SUNDRY NOTICES AND REPORTS ON WELLS
Do not use this form for proposals to drill or to re-enter an abandoned well. Use Form 3160-3 (APD) for such proposals.

8. Well Name and No.
Scott E Federal # 1

9. API Well No.
30-025-27442

Scott E Fed #1 Wellbore Diagram (UCT543600) Proposed Wellbore

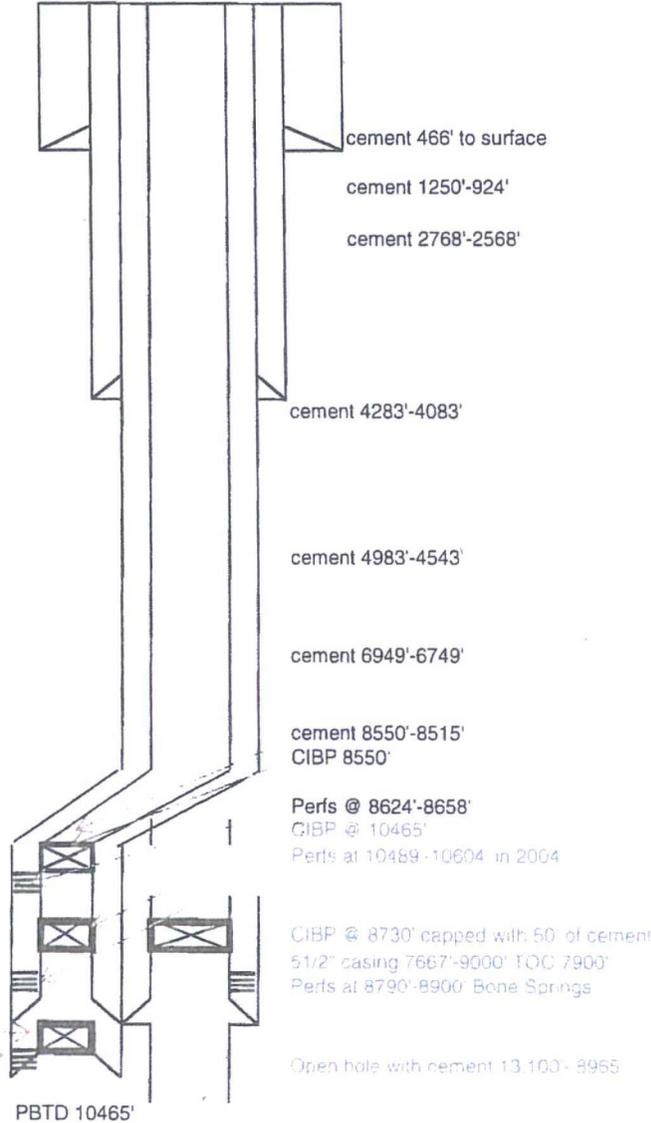
11 3/4" 42# @ 416' TOC surface, 8 5/8" 28# 4158' TOC surface, 5 1/2" 17# @ 11,975' TOC 3658', Perfs 8624'-8658'
Chevron respectfully requests to abandon this well as follows: **ADD. RIH Tag CIBP + 35' cmt 4/ 10430, spot cmt (class H) to 10238. woc tag. (Top Wolfcamp)**

- Notify BLM 24 hrs. prior to starting work (575) 234-5909.
- MIRU, NDWH, NU BOPE, POOH with rods and tubing if present.
- Set CIBP @ **8550'**, RIH & spot 20 sx CL "C" from 8550'-8545', WOC / Tag / Test / circ gel (perfs). **25 sack Class H (190' min) CIBP @ 50-100' above perfs.**
- Mix and spot 30 sx CL "C" cement from 6949'-6749', (Bone Spring).
- Mix and spot 60 sx CL "C" cement from 4983'-4543', (Deleware, San Andres).
- Mix and spot 30 sx CL "C" cement from 4283'-4083', (8 5/8" shoe, Grayburg).
- Perf 2768' and sqz 70 sx CL "C" cement from 2768' 2568', WOC & tag (Yates, base of Salt).
- Perf 1250' and sqz 80 sx CL "C" cement from 1250'-924', WOC & tag (Top Salt, Anhydrite).
- Perf 466' and sqz 130 sx CL "C" cement from 466' to surface.
- Cut off wellhead 3' below grade, install required dry hole marker as per COA's, turn over to reclamation.

Below ground level dry hole marker required.
All cement plugs will be class "C" with a closed loop system used.
See Attached COA's Class H below 7500'
